56 MHz SRF upgrade and commissioning

C-AD MAC-08
BNL • November 2 – 3, 2011

Mar'2011 review of the project

Response to the recommendations

Recommendations on HOM coupler

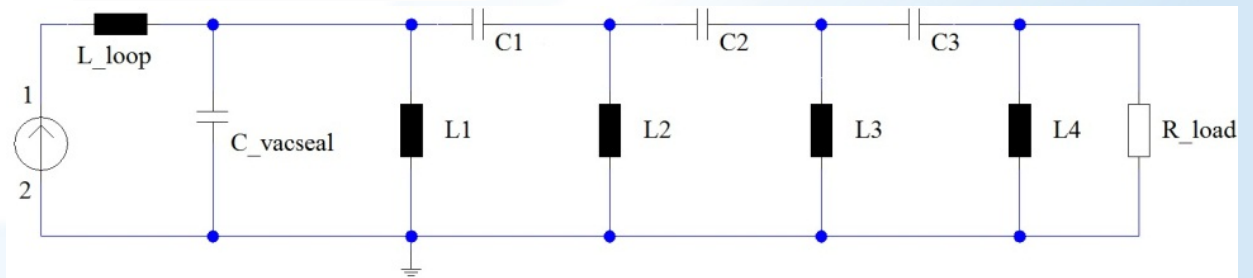
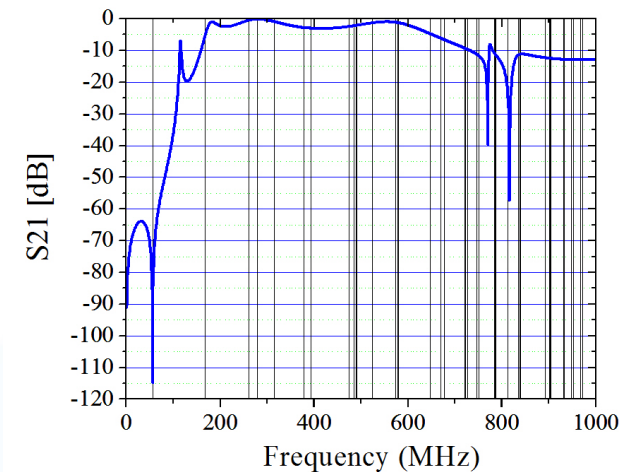
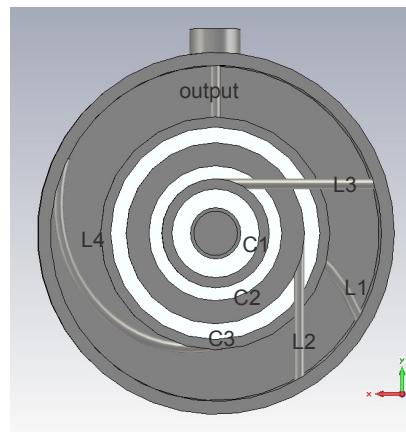
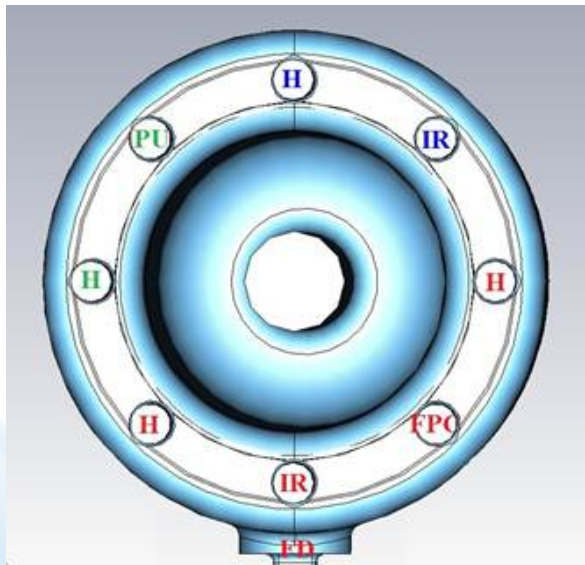
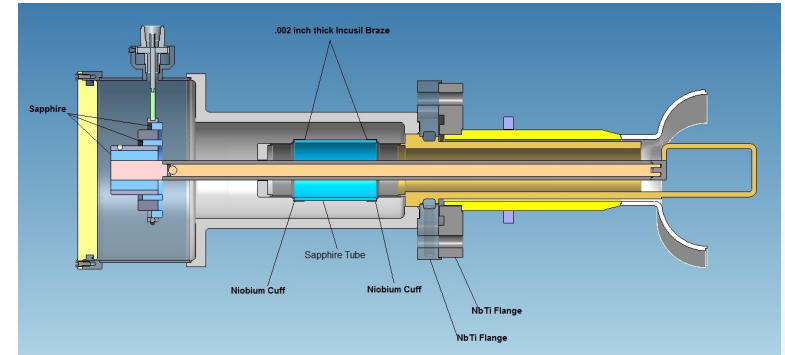
3. Given the high risk of the HOM damper design (issues with potential multipacting, thermal environment, materials, etc.) a workshop or external review strictly on the HOM damper involving other members of the SCRF community is highly recommended.

4. The HOM design should be checked with the anisotropic characteristics of dielectric and coefficient of linear thermal expansion constants of sapphire.

5. Additional multipacting studies on the HOM damper should also be carried out. This should include the study of whether coating of the sapphire window needs to be carried out to bleed charge and/or prevent multipactor.

6. Develop an experiment with the HOM coupler and cavity in the vertical test facility that closely mimics the actual cooling techniques and operating conditions (particularly thermal ones) of the HOM coupler.

7. Evaluate whether use of simple temperature diodes on the Nb surface in insulating vacuum on the cooling conduction path would provide a more reliable and economical source of HOM damper quench interlock. Also, include consideration of how the cavity loaded-Q will change with normal-conducting HOM loop and how the FPC RF control system might promptly sense that and provide an independent interlock condition.

Response to recommendations on HOM coupler

- HOM coupler has undergone significant re-design to improve cooling. We are quite confident now that the design is adequate.
- The sapphire parts will be ordered with a specific crystal orientation and its anisotropic properties are being taken into account.

- Multipacting studies are under way.
- Effectiveness of HOM damping will be checked on a copper model of 56 MHz cavity with the first article HOM coupler. One HOM coupler will be installed on the cavity for the second vertical test. The installation will closely mimic operating conditions in the cryomodule.

- Two IR sensors will be installed for the second vertical test as well to test quench detection. Analysis showed that the response time of temperature diodes installed outside the HOM coupler is too slow to adequately protect against a quench. Work continues on the IR detector. As the cavity is beam-driven, RF control loop will not be sensitive to change of loaded Q .

- However, quench will be accompanied by sudden RF power increase on 28 MHz cavity. This may be used for quench detection.

Response to the recommendations (2)

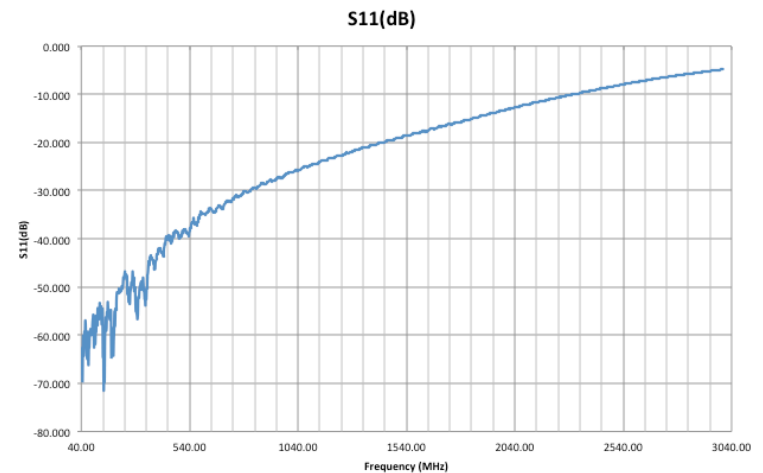
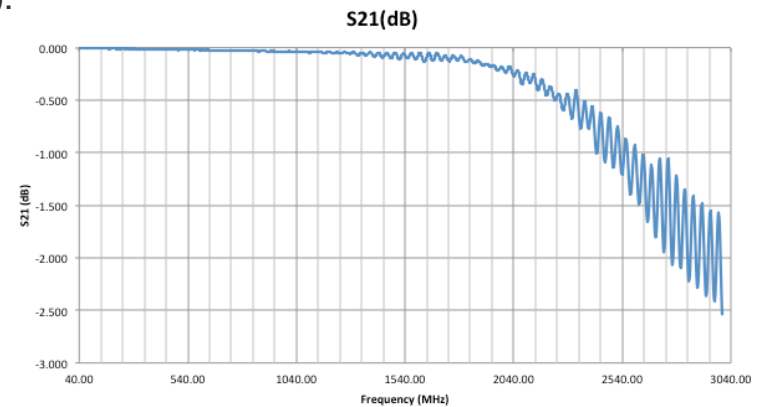
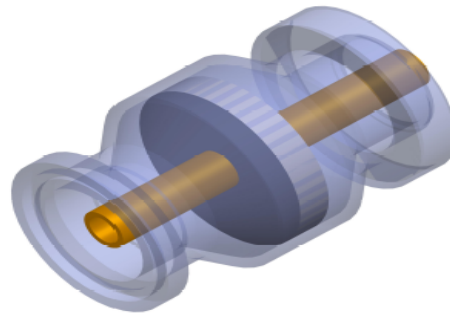
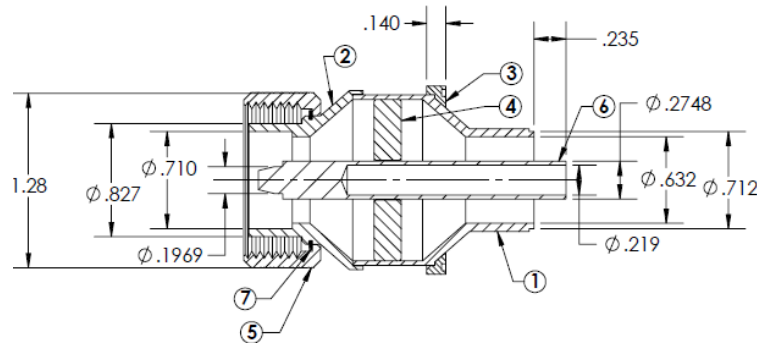
8. It is strongly recommended to construct a dummy cavity from inexpensive materials with similar mass and interface points. The dummy cavity should be used to commission handling procedures, HPR procedures, and clean assembly procedures (including coupler insertion and mounting without cavity contact or particulate generation).
 - Processing equipment will be tested using mock-up components, and procedures will be verified prior to actual processing. A full size dummy cavity will not be fabricated for a single component run.
9. Specific test criteria that indicate success should be developed for each major component.
 - HOM coupler will be tested with the cavity in VTF. RF windows will be tested at room temperature to full power. Test criteria for other major components are under consideration.
